ATTACHMENT 2
TECHNICAL SPECIFICATION PAGES WITH PEN AND INK CHANGES

LICENSE AMENDMENT APPLICATION
REVISION OF DIESEL FUEL OIL STORAGE
AND TRANSFER REQUIREMENTS
HOPE CREEK GENERATING STATION
FACILITY OPERATING LICENSE NO. NPF-57
DOCKET NO. 50-354

LR-N96008
LCR H96-02

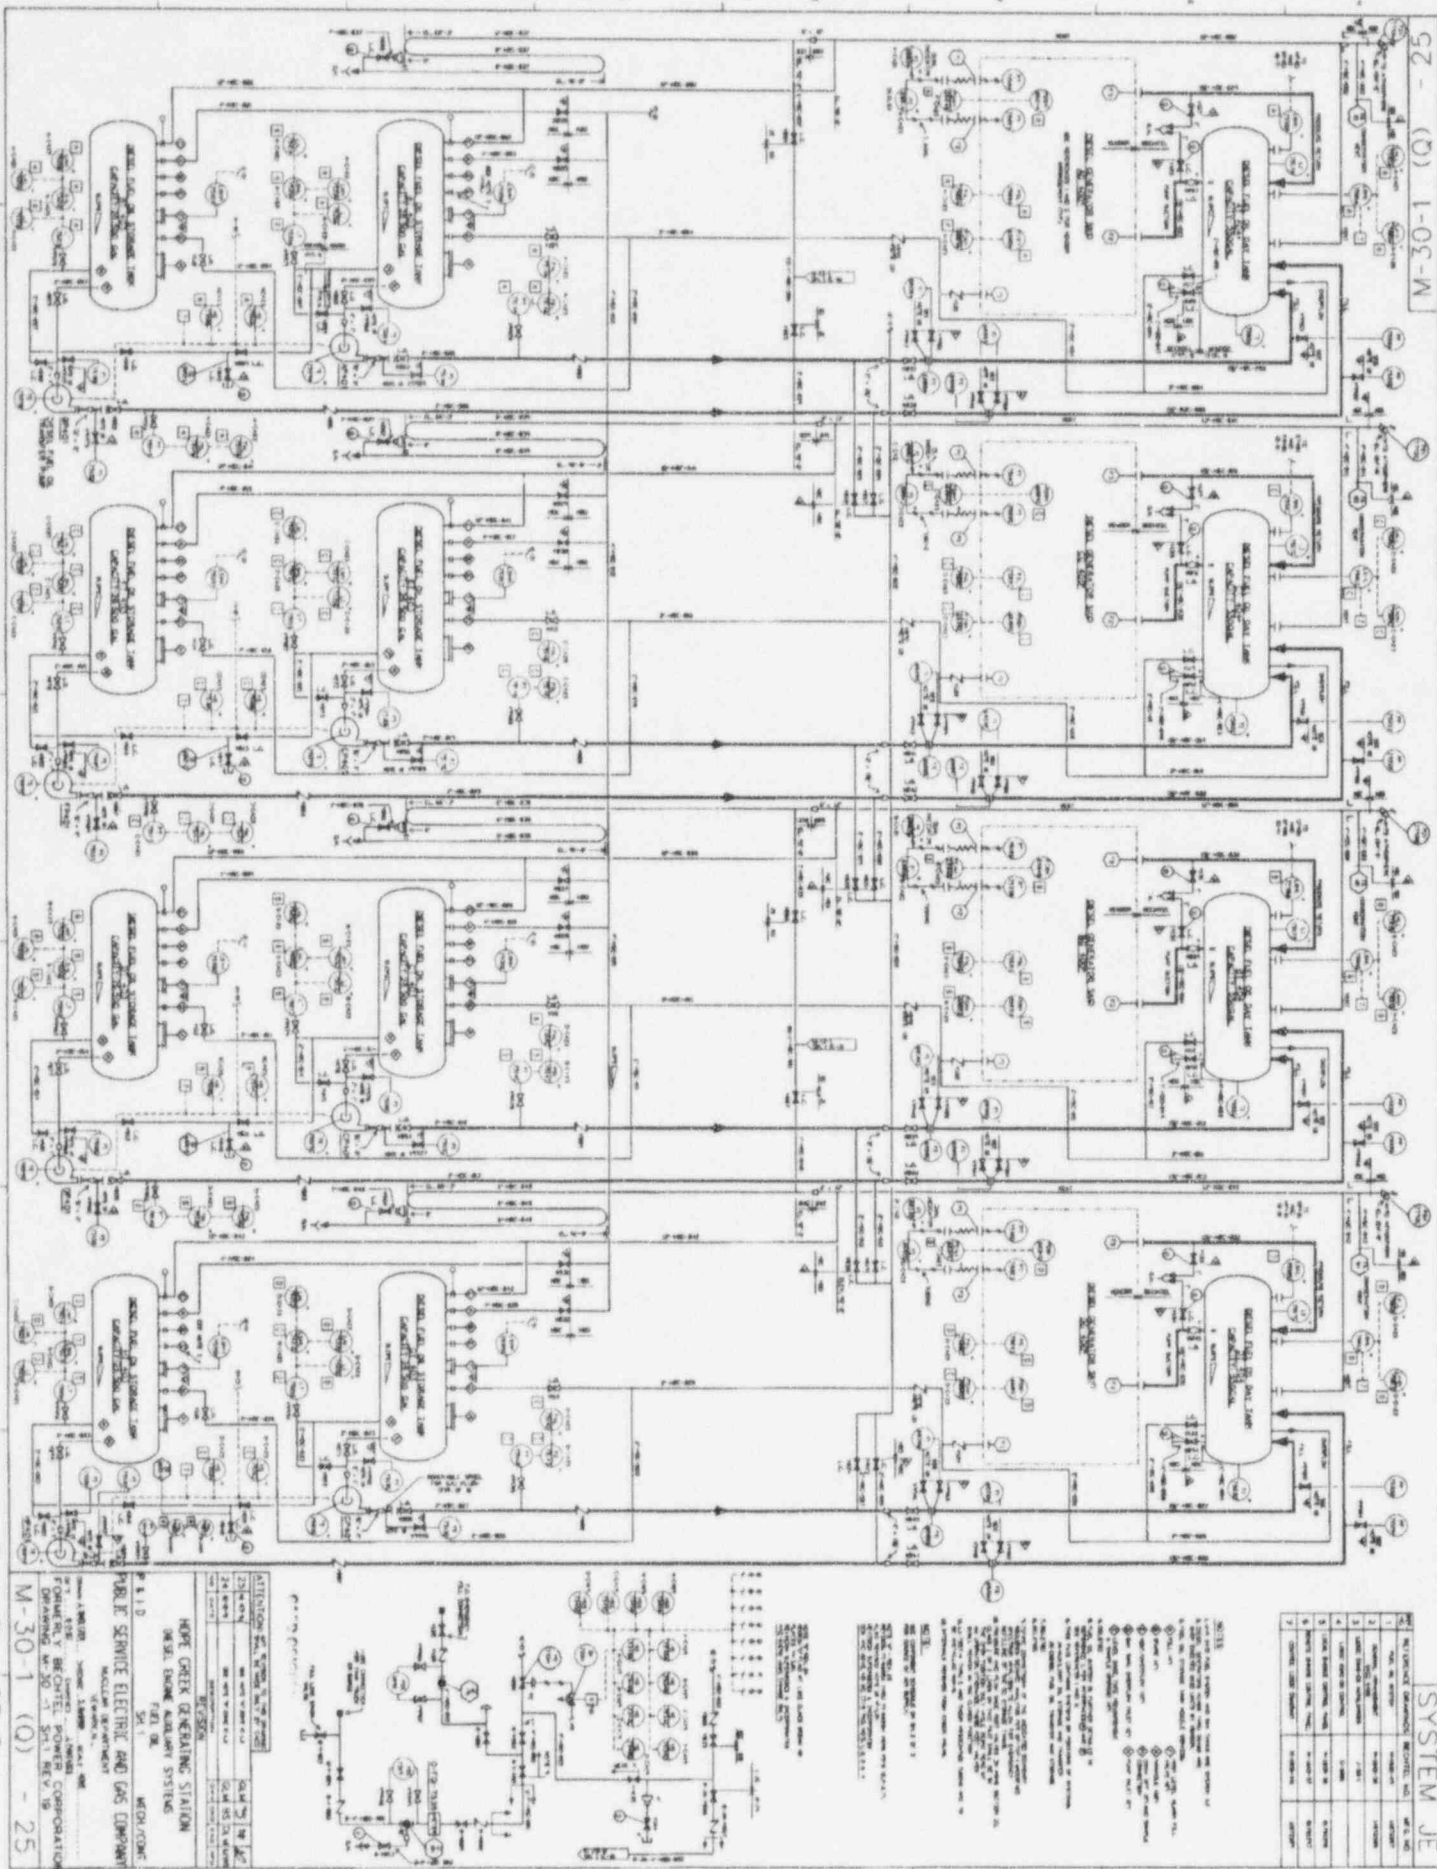
With one fuel oil transfer pump inoperable, realign the flowpath of the affected tank to the tank with the remaining operable fuel oil transfer pump within 48 hours and restore the inoperable transfer pump to OPERABLE status within 14 days, otherwise declare the affected emergency diesel generator (EDG) inoperable. This variance may be applied to only one EDG at a time.
